Project	IEEE 802 Executive Committee Study Group on Mobile Broadband Wireless Access < http://ieee802.org/20 >	
Title	Comments on 802.20 Requirements Document Rev 3	
Date Submitted	2003-07-16	
Source(s)	Mike Youssefmir 2480 N. First Street, Suite 200 San Jose, CA 95131-1014	Voice: N/A Fax: 408-428-9083 Email: mike@arraycomm.com
	Joanne Wilson 2480 N. First Street, Suite 200 San Jose, CA 95131-1014	Voice: 202-669-4006 Fax: 408-428-9083 Email: joanne@arraycomm.com
	Todd Chauvin 2480 N. First Street, Suite 200 San Jose, CA 95131-1014	Voice: 408-952-1829 Fax: 408-428-9083 Email: chauvin@arraycomm.com
	John Chen 2480 N. First Street, Suite 200 San Jose, CA 95131-1014	Voice: 408-952-1829 Fax: 408-428-9083 Email: jchen@arraycomm.com
	Marc Goldberg 2480 N. First Street, Suite 200 San Jose, CA 95131-1014	Voice: 408-952-1829 Fax: 408-428-9083 Email: marcg@arraycomm.com
	Branislav Meandzija 2480 N. First Street, Suite 200 San Jose, CA 95131-1014	Voice: 408-952-1829 Fax: 408-428-9083 Email: bran@arraycomm.com

Comments and Changes to Document Rev3

Figure 1—IEEE 802 RM for end stations (LAN&MAN/RM)

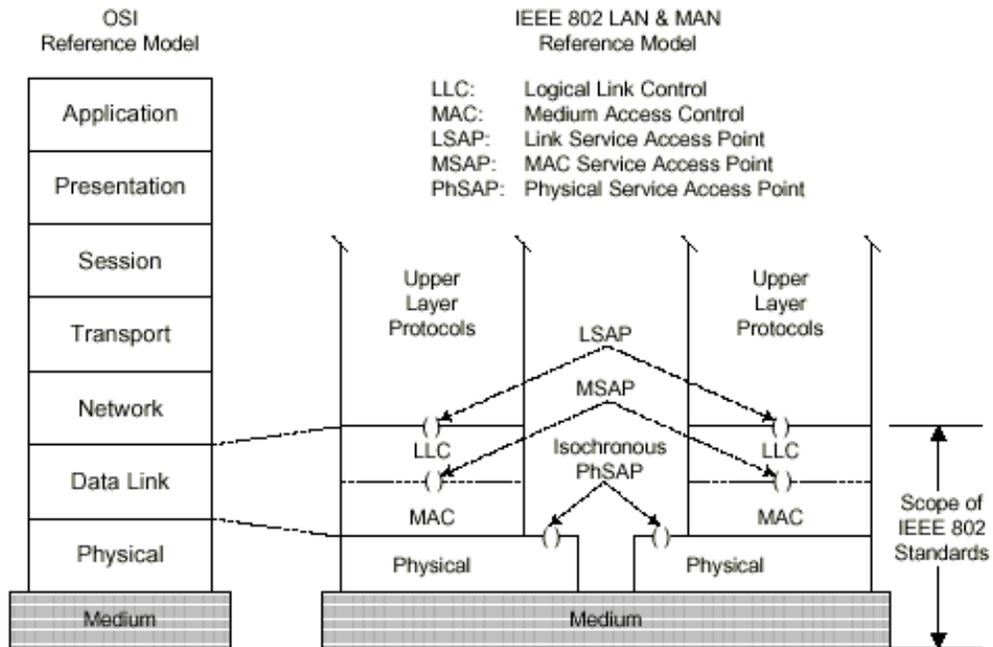
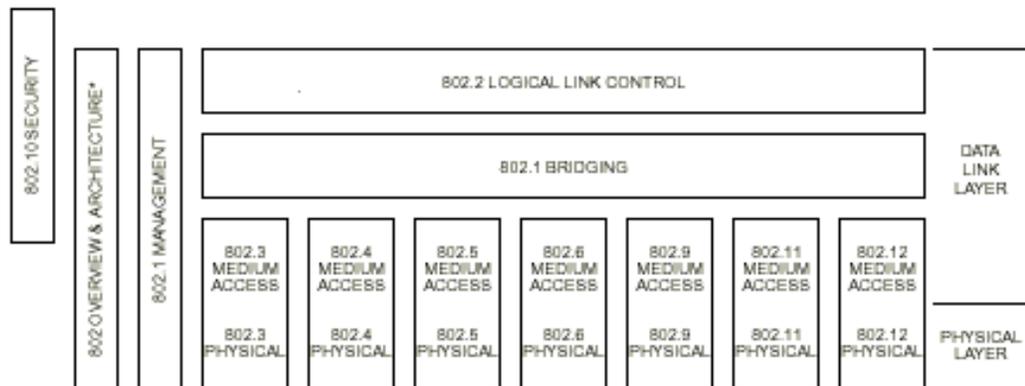
Proposal 2: Delete Figure 1 and insert two new figures consisting of slides 8 & 9 of the slide deck sent by Alan Chickinsky to the requirements group on Jun 21 2003. These figures are attached below.

Reason: This section is currently overly detailed and proposes a specific division of capabilities within the MAC and PHY layers that should be addressed in the specification itself and not in the requirements document. Alan's breakdown and slides are far more instructive in terms of what reference model we should follow.

Footnote to the new Figure 1 with: "Source: IEEE Std 802-2001, IEEE Standards for Local and Metropolitan Area Networks: Overview and Architecture, IEEE Std 802 - 2001"

Footnote the new Figure 2 with: "Source: IEEE Standard for Information technology, Telecommunications and information exchange between systems, Local and metropolitan area networks: Specific requirements Part 2: Logical Link Control, ANSI/IEEE Std 802.2, 1998 Edition, .Introduction to ANSI/IEEE Std 802.2, 1998 Edition"

"To facilitate a layered approach, the 802.20 specification shall incorporate a reference partitioning model consisting of the MAC and PHY. This layered approach shall be generally consistent with other IEEE 802 standards and shall remain generally within the scope of other IEEE 802 standards as shown in Figures 1 & 2."
